Access Compliance Report Public Rights-of-Way (Curb Ramps)

Main Street: N/A Cross Street: SENDERO_WAY Location: W

ADA ID: RPAT220208102234 Ramp Type: Type 7 - Directional 2 Initial Pass/Fail: Fail Overall Compliance: No Severity Score: 15

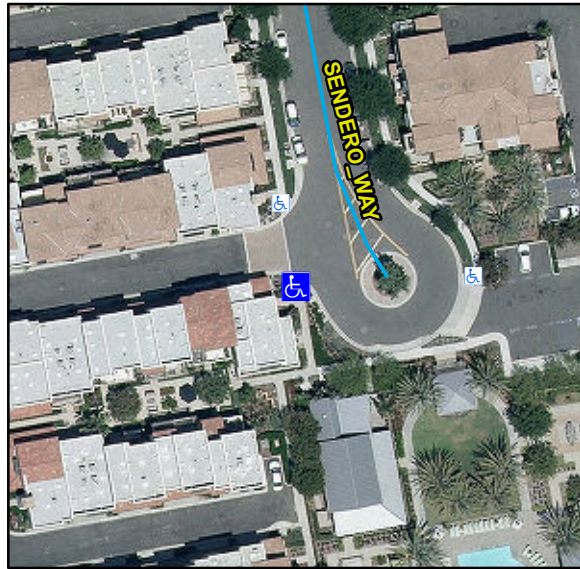
R304.2.2, STD 1115

Remove & Replace Entire Ramp.
